To: INCITS Technical Committee T10
From: Kevin Butt
Date: Printed Monday, April 27, 2009 9:04 pm
Document: T10/08-025r4 — Persistent Reservations - Team

Introduction

Proposal

Figure 1 — Device server interpretation of PREEMPT service action

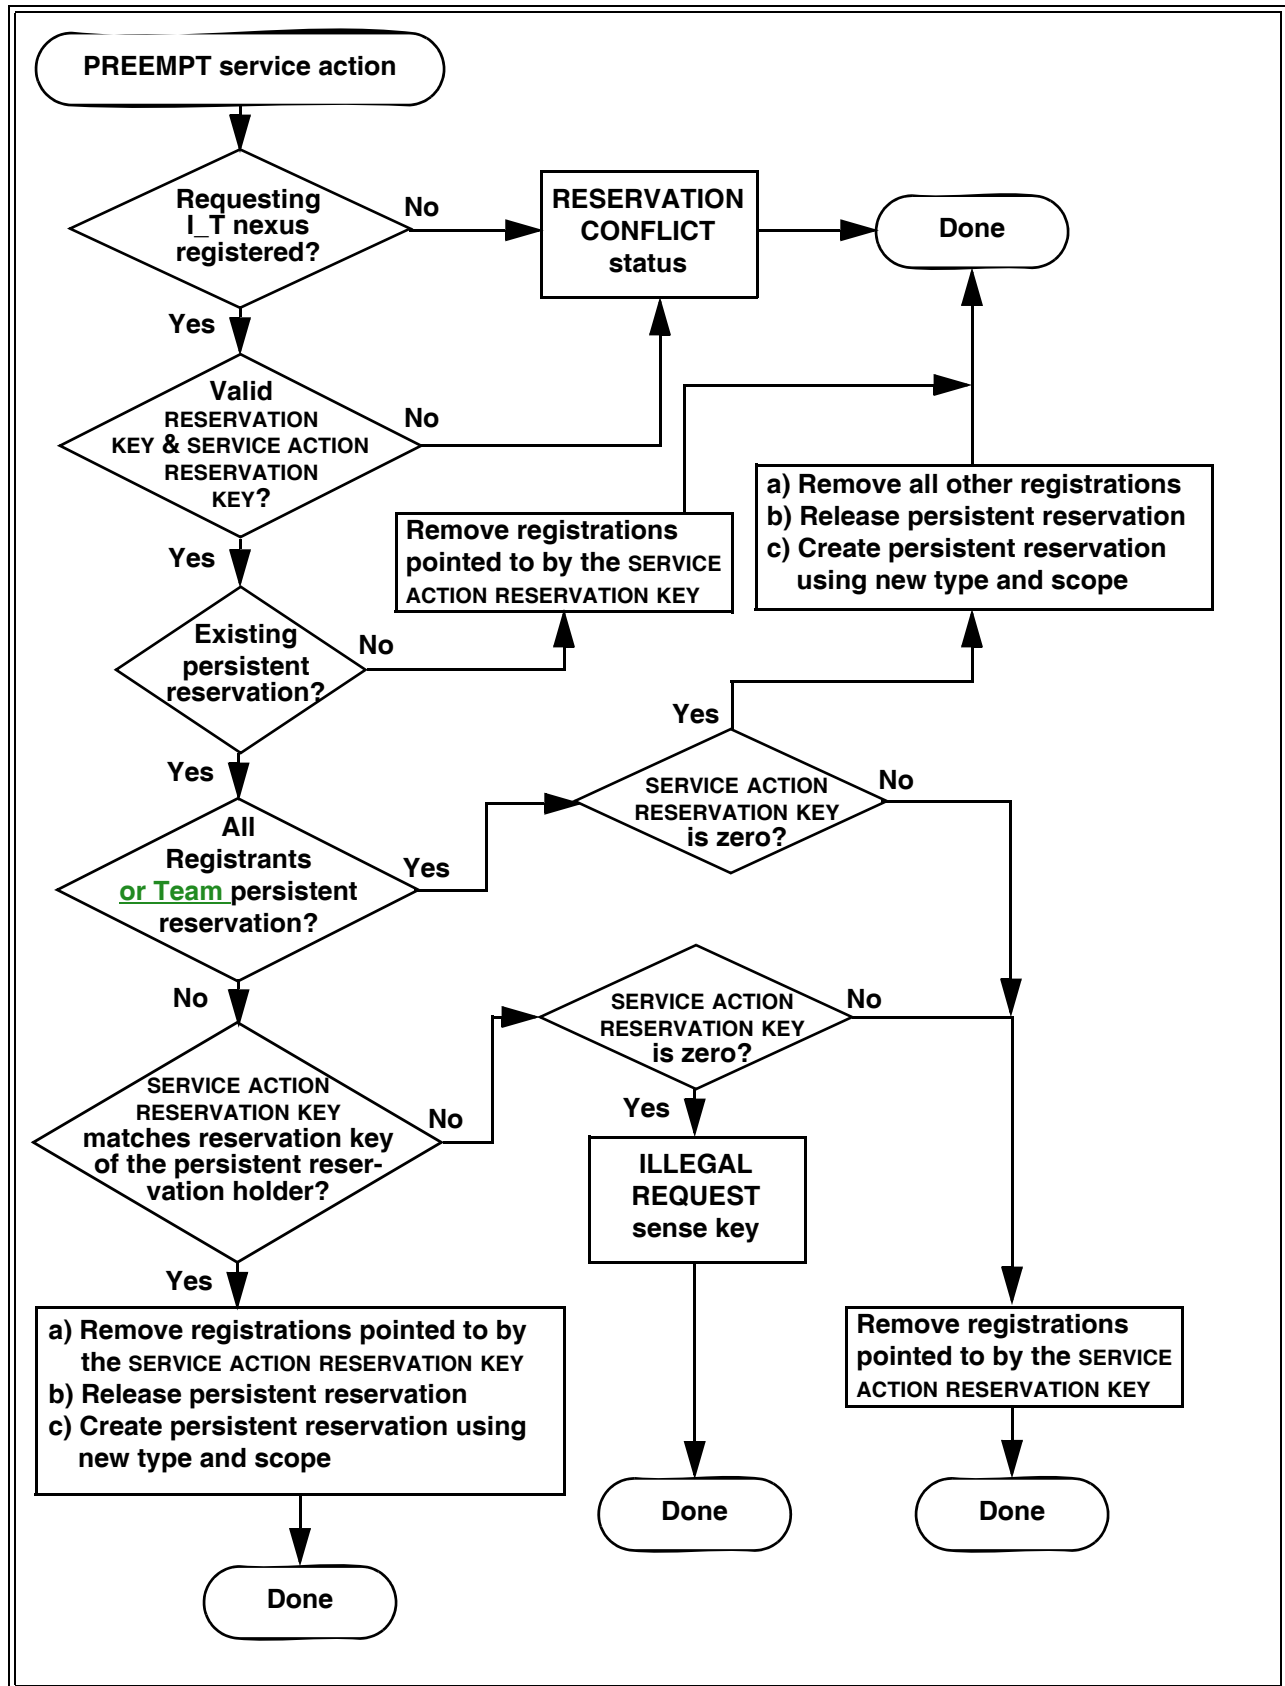
See figure 7 for a description of how a device server interprets a PREEMPT service action to determine its actions (e.g., preempt the persistent reservation, remove registration, or both preempt the persistent reservation and remove registration).
